Executive Order G-70-36-D

Relating to the Modification of the Certification of the
OPW Balance Phase II Vapor Recovery System
for Service Stations

EXHIBIT 4

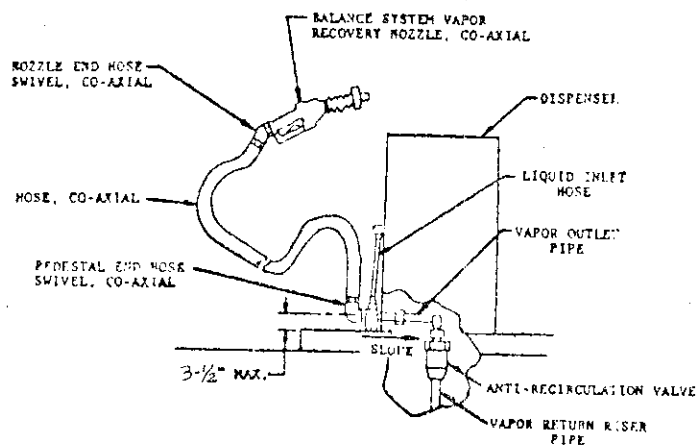
1. Allow eight to nine feet basic hose length for the B. F. Goodrich co-axial hose assembly, described in Exhibits 4 and 5, and
2. To require float check valves (or alternate equipment, design, or operating procedures acceptable to the Air Resources Board) for all manifolded piping installed 150 days after the effective date of this certification modification, to prevent contamination of unleaded gasoline with leaded gasoline, via vapor recovery piping, during underground storage tank loading or overfill.
